**MFN 10-293**

**ESBWR Licensing Topical Report**

**NEDO-33083 Supplement 1-A Revision 2**

**TRACG APPLICATION FOR ESBWR STABILITY  
ANALYSIS**

Figure 6

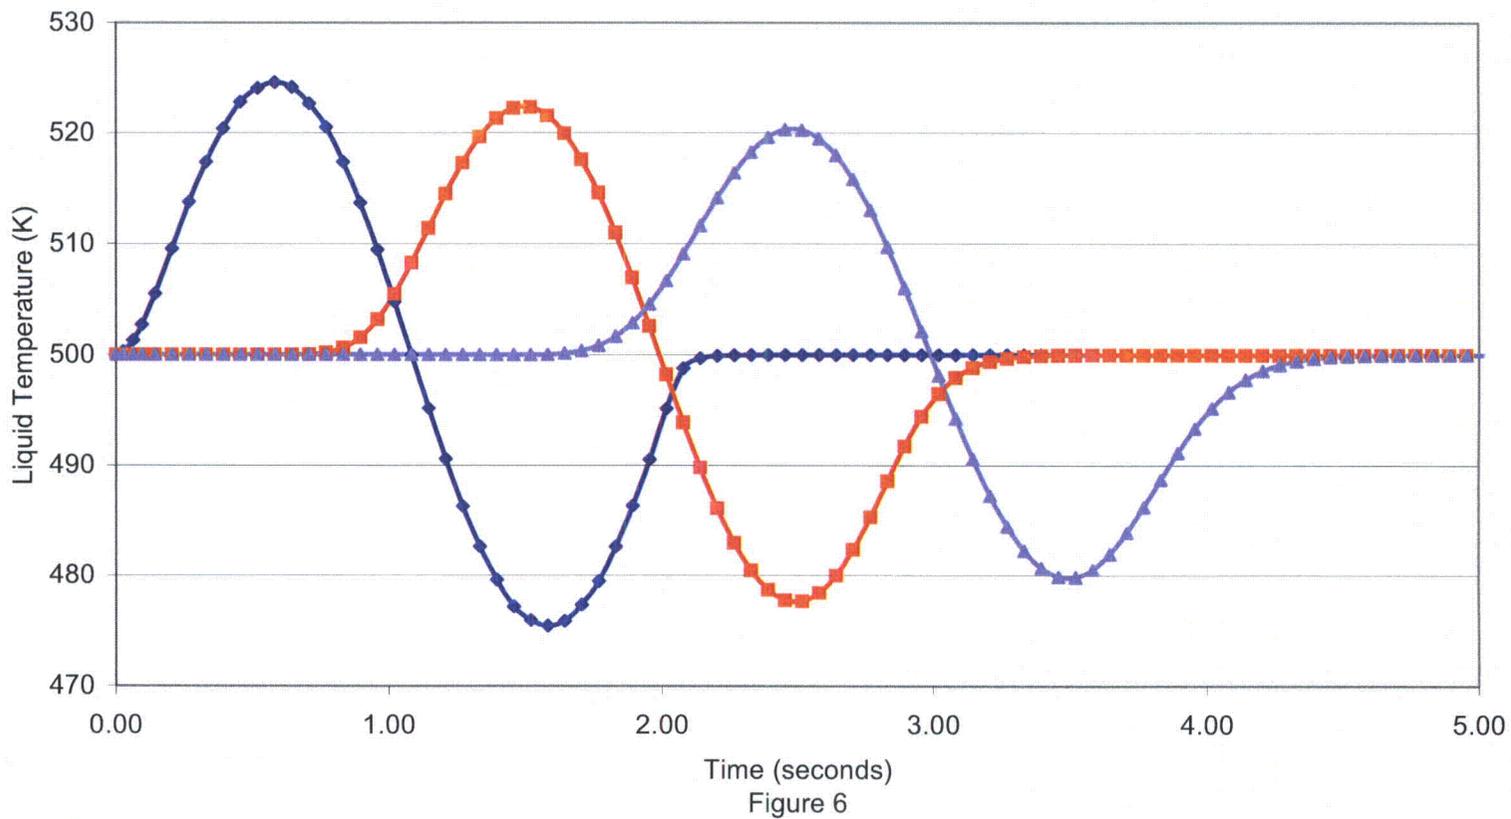
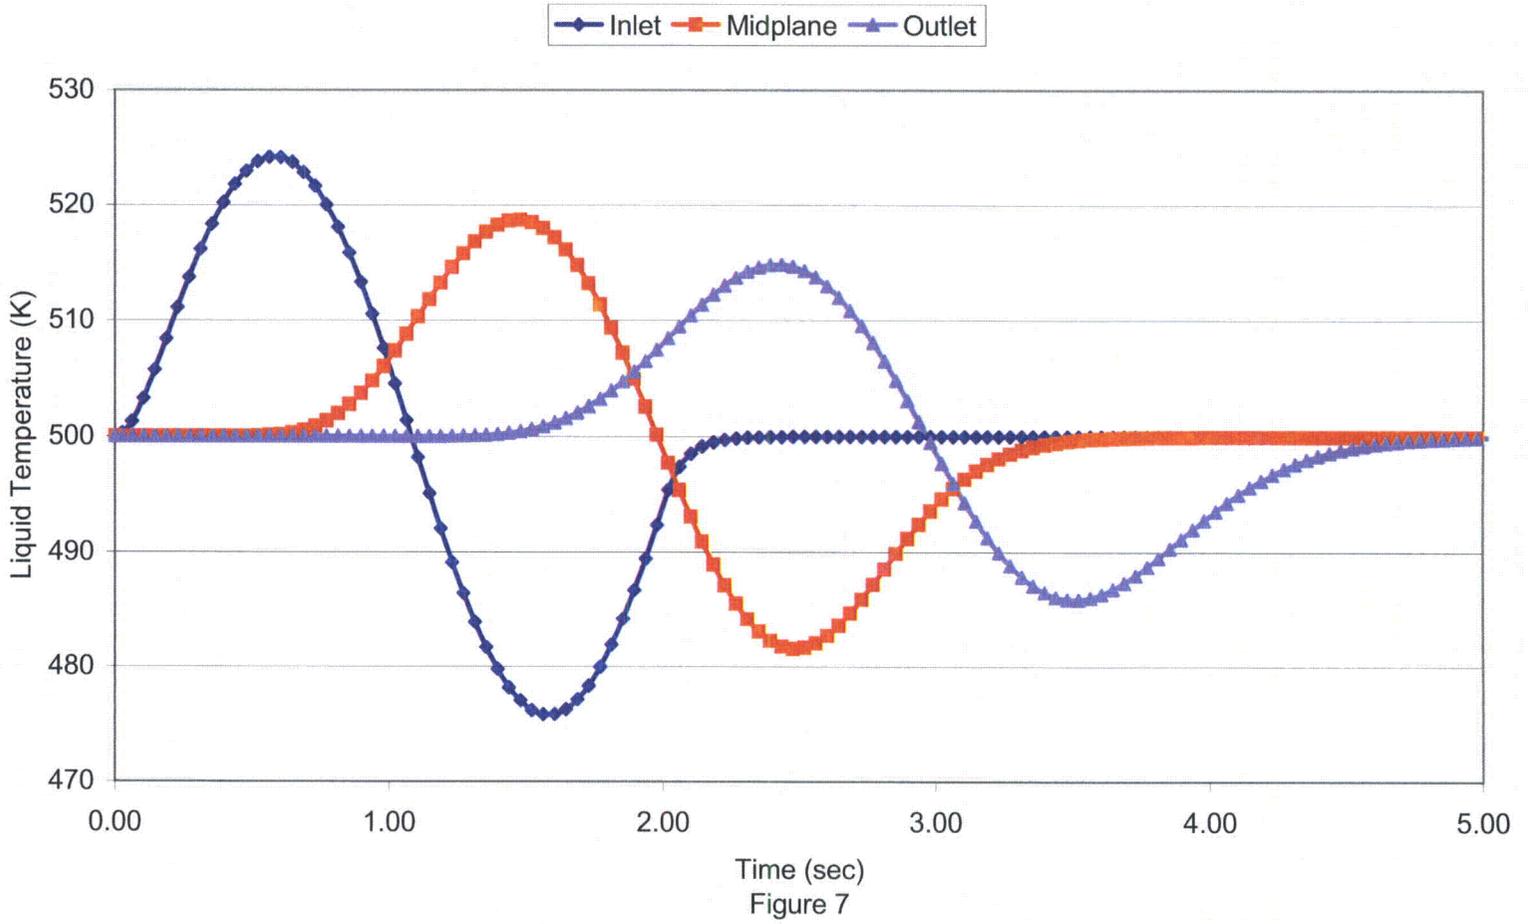
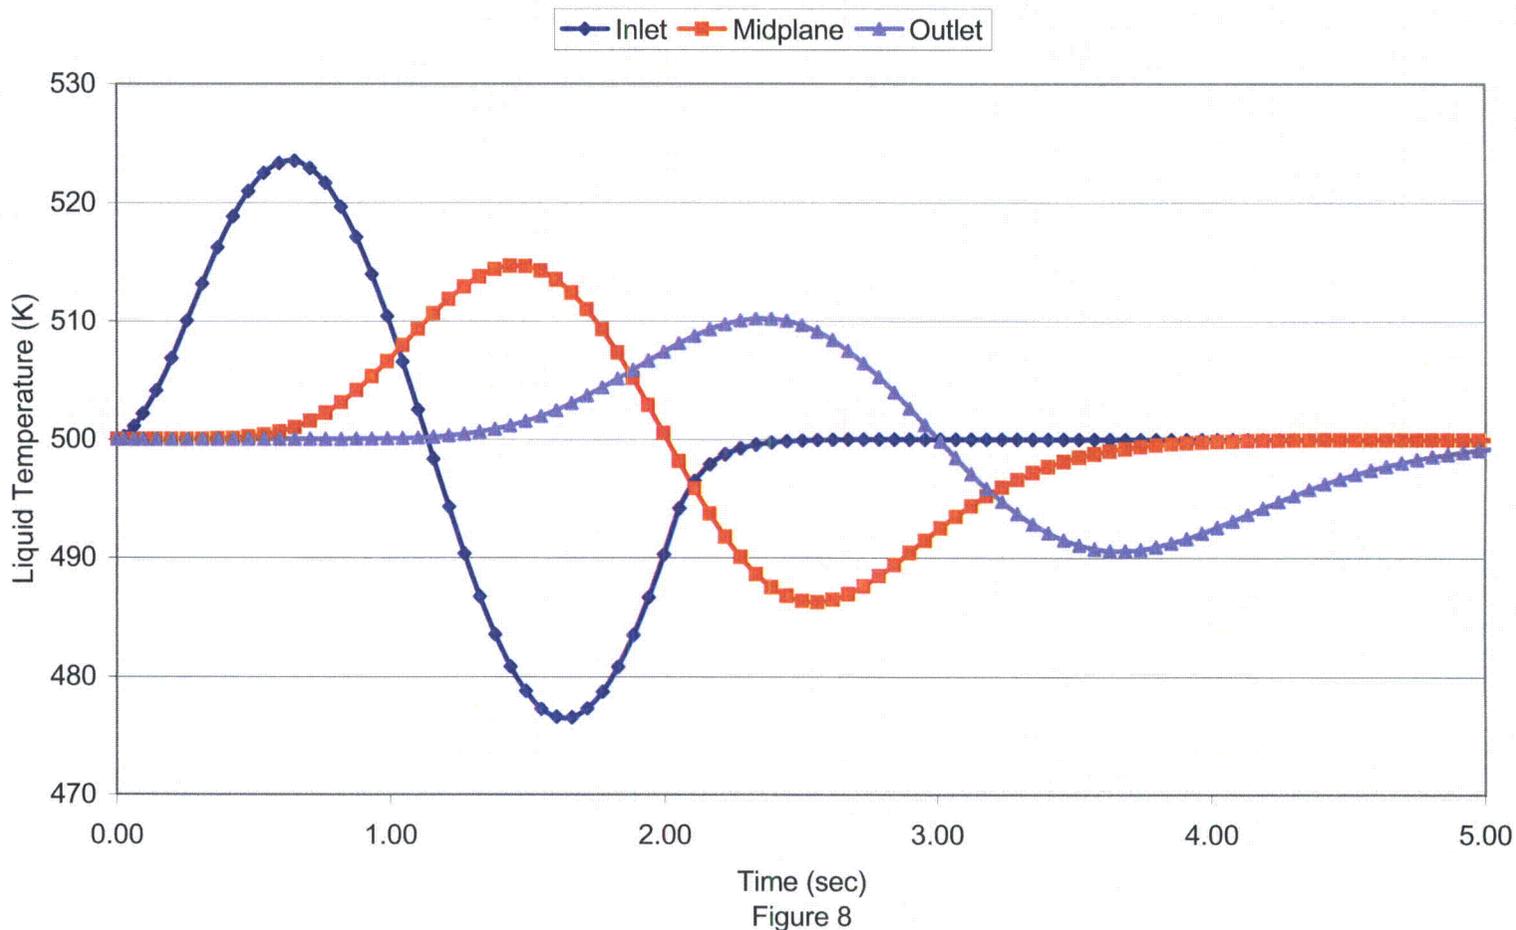
figures. Figure 8 of this SE shows the difference when the implicit method is used. There is noticeable dissipation as compared to Figure 6, which has the same Courant multiplier. This demonstrates that use of the explicit method option and GE's process for nodalizing the core and setting the Courant multiplier to 1.0 are appropriate for minimizing numerical dissipation in a time domain code.

Figure 1. ESBWR Hot Channel Void Fraction Profile Predictions.

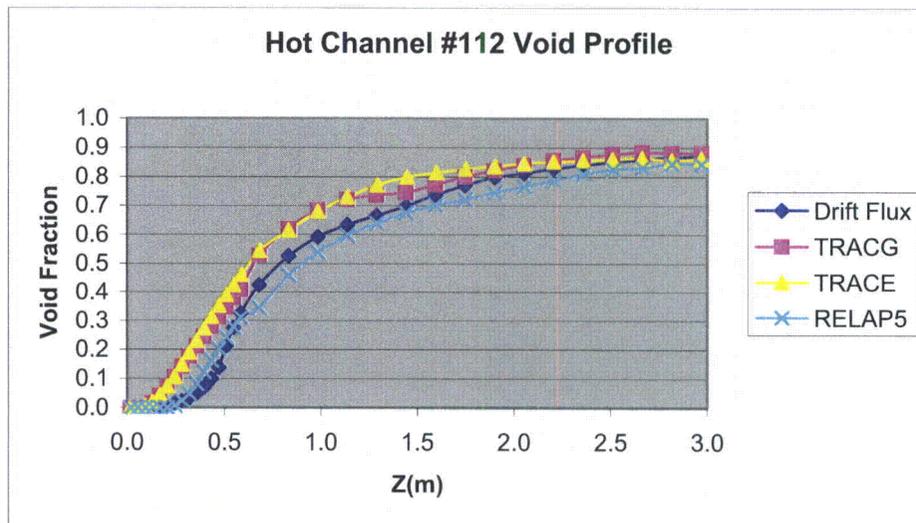
A standalone drift flux program for a single ESBWR channel was developed to estimate the steady-state void fraction and velocity profiles. The standalone drift flux program includes TRACG documented models (Reference 11) for the drift flux parameters and subcooled boiling. Based on this model the estimated density wave transport time for the ESBWR hot bundle is [[ ]] seconds, which implies an instability frequency of

[[ ]] Hz. This is slightly below the lower range of expected frequencies for the ESBWR. One explanation for the difference in transport times is the difference in void fraction profiles between TRACG and the standalone drift flux program. Comparison of the void fraction profile predicted by the drift flux standalone program to TRACG, TRACE (Reference 12), and RELAP5 (Reference 13) for the ESBWR hot channel is given in Figure 1.

**RAI 14 Response** [MFN 05-146] [MFN 05-146, Supplement 1 (Re-submittal with Correct Proprietary Designation)]

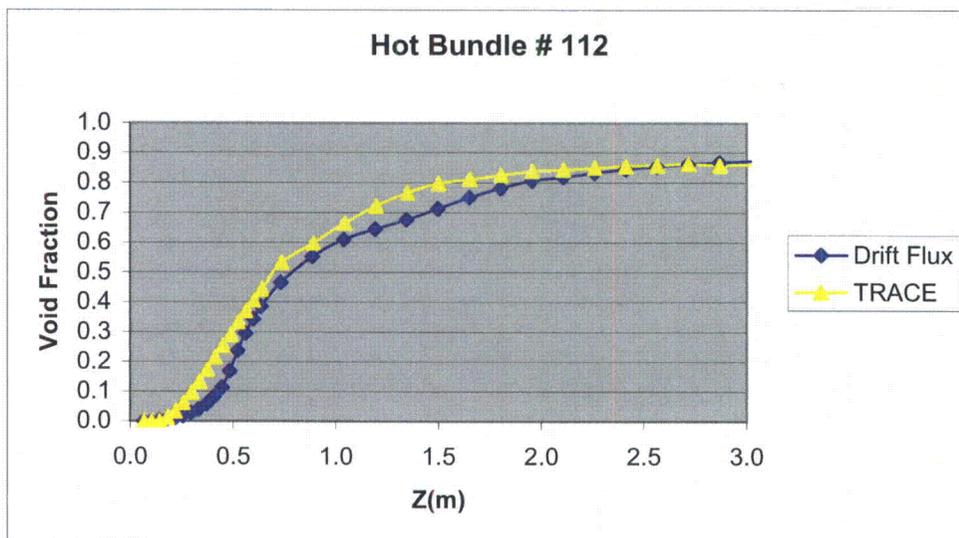
BOC is bounding exposure for channel decay ratio. MOC is bounding exposure for core decay ratio. What about a clean core (i.e. zero exposure) rather than an equilibrium cycle? Have any calculations been completed for completely fresh core (i.e. zero exposure)?

An initial core design has not been developed for the ESBWR. For purposes of demonstrating the application methodology, an equilibrium core was judged to be sufficient. The actual initial core will be analyzed using the approved methodology at COL.
